# **Scoping Summary Report**

## **Supplemental Environmental Impact Statement for the Proposed Kendrick Expansion Project Crook County, Wyoming**

**October 2016**

**U.S. Nuclear Regulatory Commission  
Rockville, Maryland**

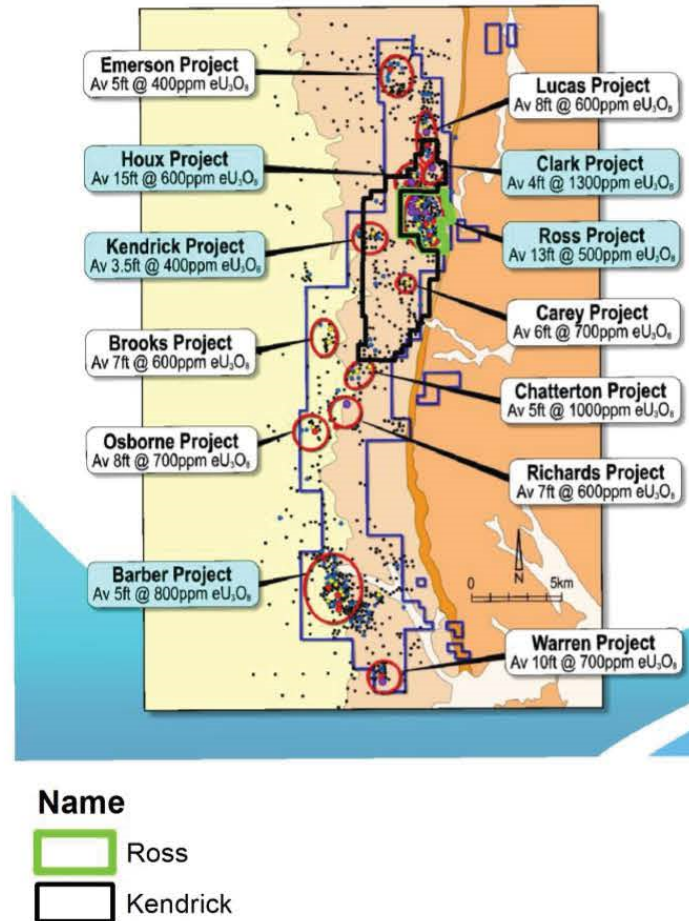
**11-6: I.** The Scope Of The SEIS Must Include The Entire Ross Project, Which Includes Not Only The Ross Project And Kendrick Expansion, But Also The Further Expansions That Will Inevitably Occur In The Lance District.

As the Organizations explained in challenging the segmented scope of the Ross Project SEIS, the Commission was required by NEPA and implementing regulations to prepare a single, comprehensive EIS that considers the environmental impacts of SEI's plans for ISL mining throughout the Lance District, including not only the initial Ross Project and the Kendrick Expansion, but also Richards and Barber areas. Indeed, it has long been evident from Peninsula Energy public documents and statements that SEI will inevitably be developing *all* of these areas. See, e.g. Figure 1 below.

All of the projects depicted in Figure 1 are reasonably foreseeable and have been proposed by SEI as expansions of its original Ross Project. They are adjacent to each other in geography and connected via a central processing facility. They are also connected via watersheds, aquifer systems, mineral-bearing formations, ingress and egress roads, and any number of areas whose connection directly bears on the full scope of the impacts.

**Response:** *As the commenter recognized, in LBP-13-10 and a subsequent unpublished order, ASLB declined to admit a contention asserting that the staff's NEPA analysis for Ross should consider the development of the entire Lance District as the Federal action. In CLI-16-13, the Commission declined to grant a review of ASLB's decisions. In its decision, the Commission took notice of the commenter's scoping comments for the Kendrick SEIS that the entire Lance District should be considered in a single EIS. The Commission stated that the staff's SEIS for Ross considered the cumulative impacts of the construction of possible satellite facilities such as Kendrick, including impacts to geology and soils, and surface and ground water impacts. Kendrick SEIS Chapter 5 will address the cumulative impacts of all past, present, and reasonably foreseeable future actions, including Strata's current and future activities within the Lance District.*
